**Report to the Future Melbourne (Planning) Committee**

**Agenda item 6.2**

**Ministerial Planning Referral: TPM-2013-31  
19-25 Russell Street and 150-162 Flinders Street, Melbourne**

**6 May 2014**

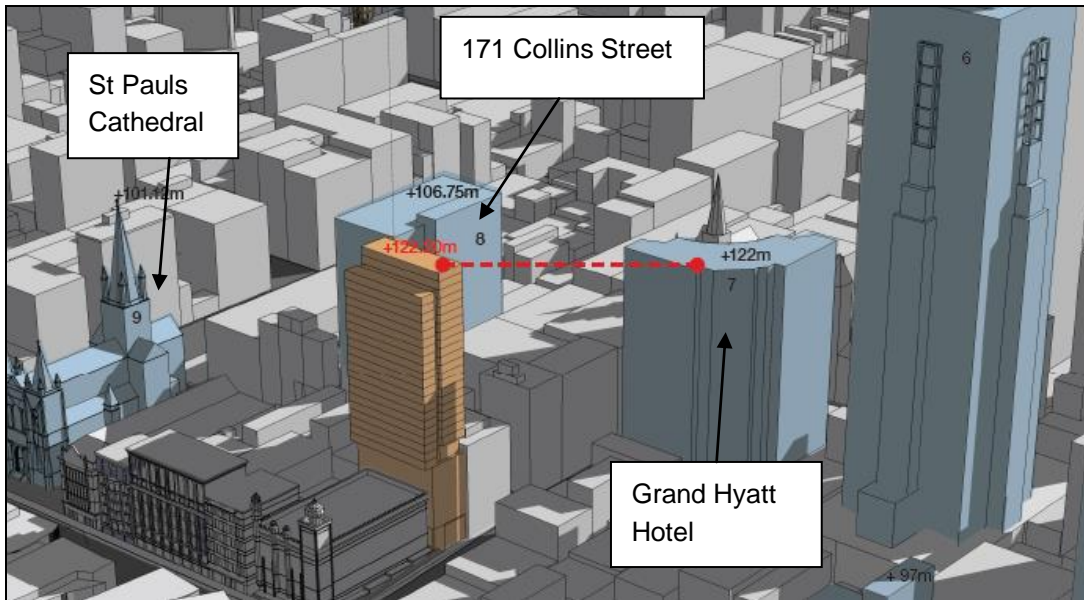
The variation to the discretionary height control is significant. At 107 metres, the proposed tower is 67 metres taller than what is recommended by DDO2-A5 (40 metres). The significant variation in height is sought in an area where the established building height is generally 40 metres or lower. The tallest structure in this block is the spire of the St Paul's Cathedral which is considered one of Melbourne's most prominent landmarks. It is 92 metres tall.

The tower does not meet the objectives and built form outcomes of the Design and Development Overlay Schedule 2 which clearly seek to preserve the low-scale nature of the area and the dominance of notable buildings. Furthermore the proposal does not meet the policy directions of Clause 21.12 Hoddle Grid and Clause 22.01 Urban Design outside the Capital City Zone.

Overshadowing 22 June 11am

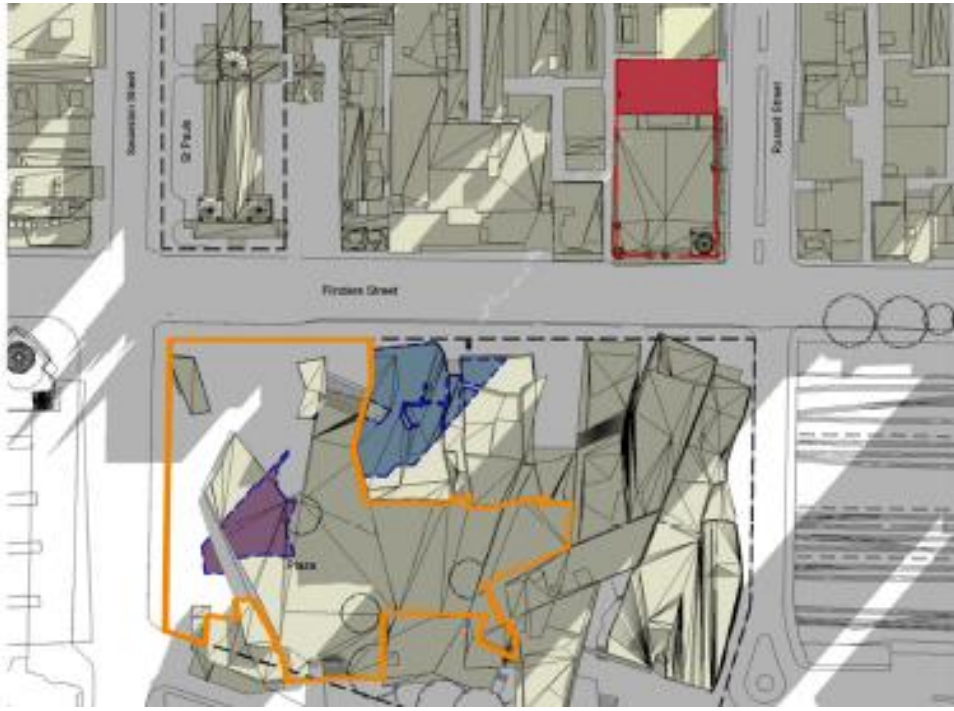
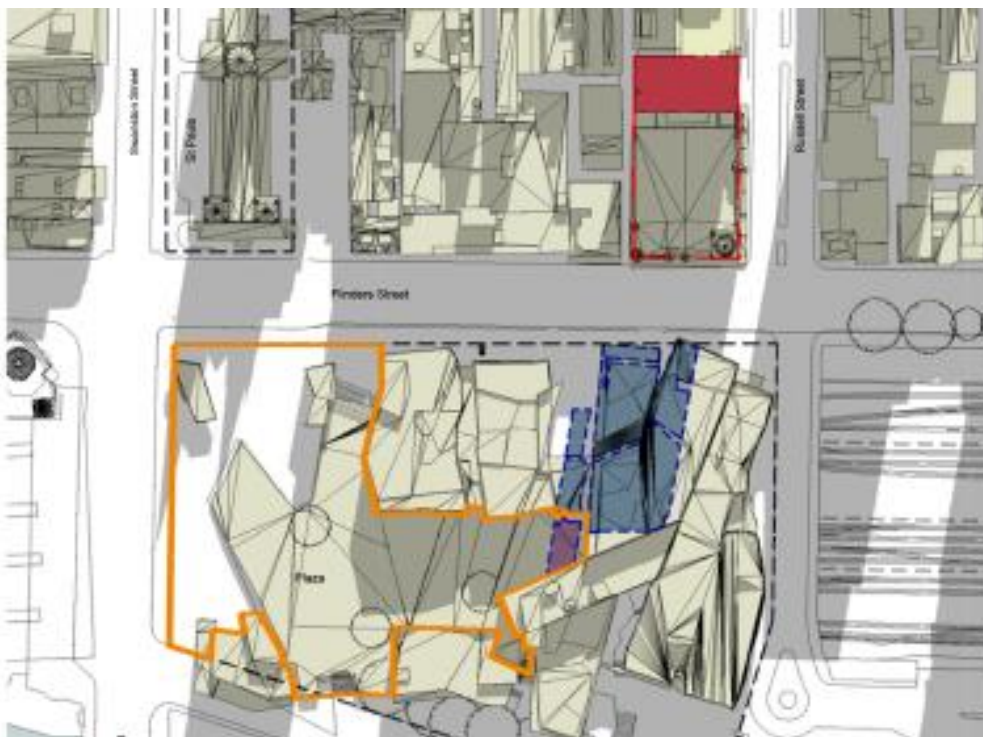
The impact on the Atrium is significant. The main source of daylight to the Atrium is provided by the north facing entry and glazed wall. The shadow diagrams provided show the roof of the Atrium being overshadowed. The impact is at its worst at 1pm. The proposed tower will not only cast a shadow over the Atrium roof but will also cast a significant shadow over the north facing Atrium opening causing the interior of the Atrium to be in shadow where it currently receives sunlight. This is an unacceptable outcome.
